# Diversified Environmental Catalysts

## Tech-Note

01-014/04

MIL ILLUMINATION WITH  
DTCS P0300 P0301 P0302 P0303 P0304 P0305 P0306 P0171  
P0174 P1170 P1173 STORED IN MEMORY

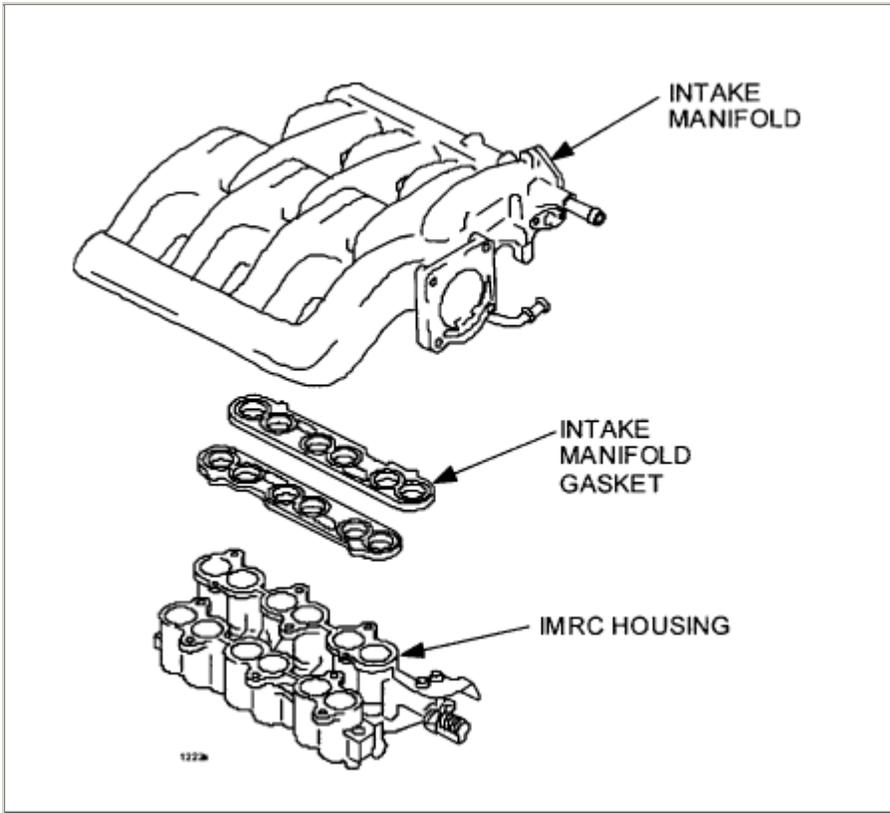
Some vehicles may experience MIL illumination with one or more of the following DTCs stored in the PCM memory.

- ^ DTC P0300 - P0306 (engine misfire)
- ^ DTC P0171 or P0174 (fuel system too lean)
- ^ DTC P1170 or P1173 (O2 sensor no inversion)

The sealing of the intake manifold gasket may be deteriorated, causing air leakage. The sealing material of the gasket has been modified to eliminate this concern.

1. Verify concern.
2. Inspect intake manifold area for air leakage.
  - ^ If air leak is found, replace intake manifold gaskets with modified parts according to the MPV Workshop Manual (section 01-13) INTAKE-AIR SYSTEM REMOVAL/INSTALLATION
  - ^ If air leak is not found, troubleshoot DTC(s) according to appropriate section of the workshop manual.
